Marathon Cty. Sheriff's Dept TRC & Storage Bldg. Renovations 1000 Lakeview Drive Wausau, WI 54403 Angus Young Associates Project No. 77081

ADDENDUM #01

Monday, March 04, 2024

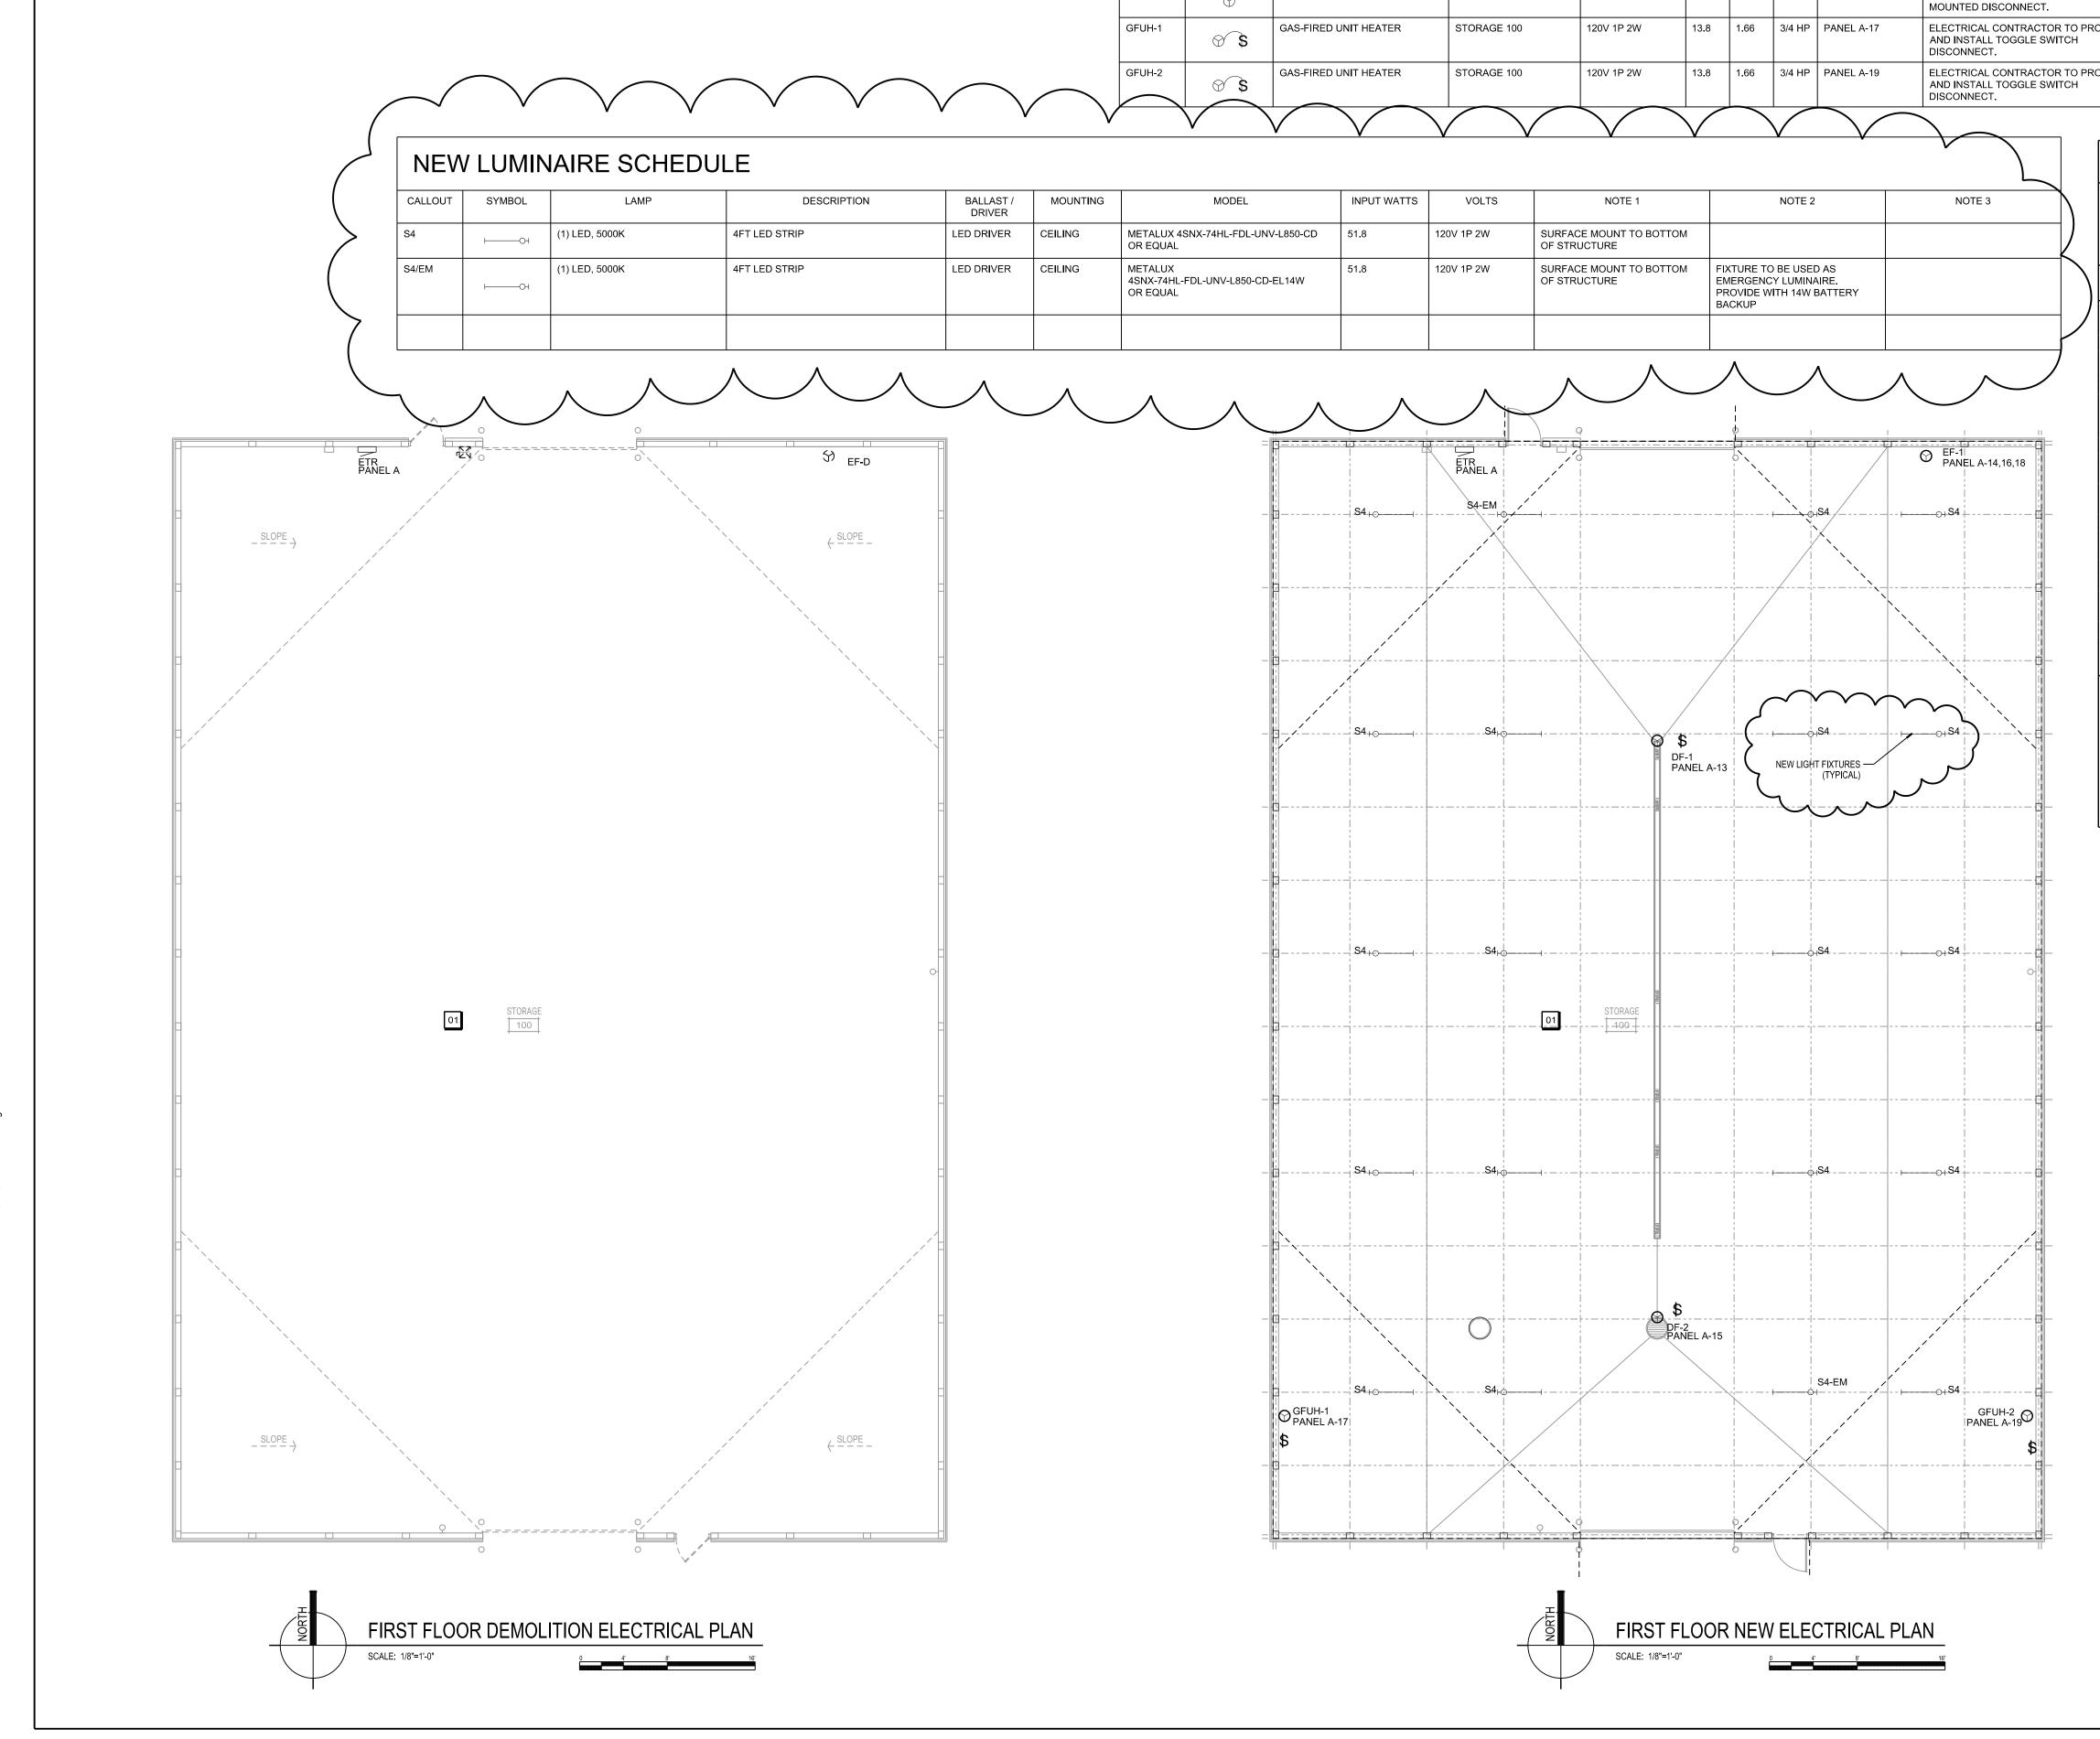
B. Sheet E101 Proposed Lighting & Power Plan:

a) Refer to revised floor plan proposing new light fixtures as indicated.

Model: SBE-2H20

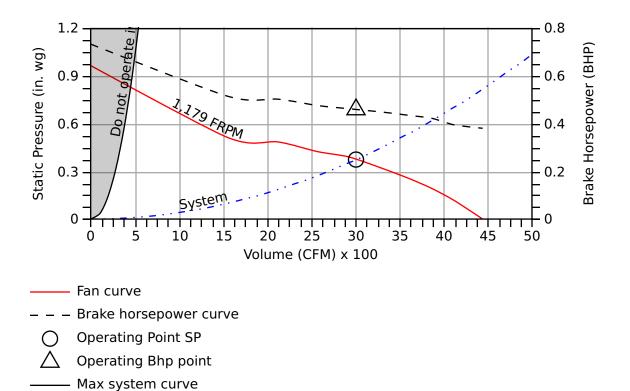
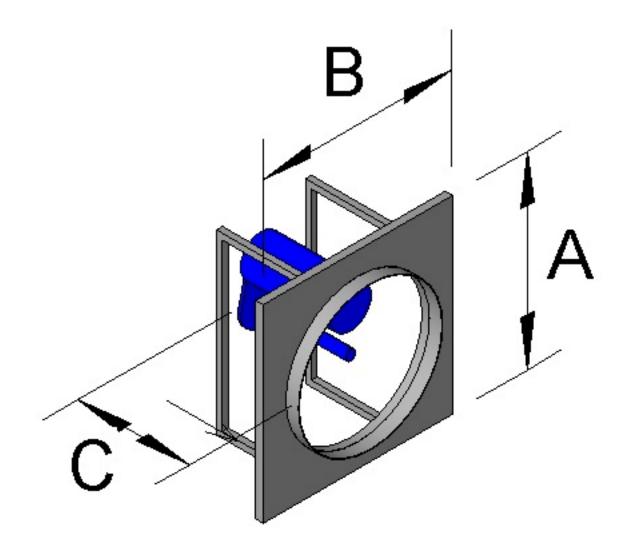
- a) Refer to the attached revised cut sheets for WEF-1 & WEF-2.
- b) Omit Keynote #01. The existing unit is to remain as is.
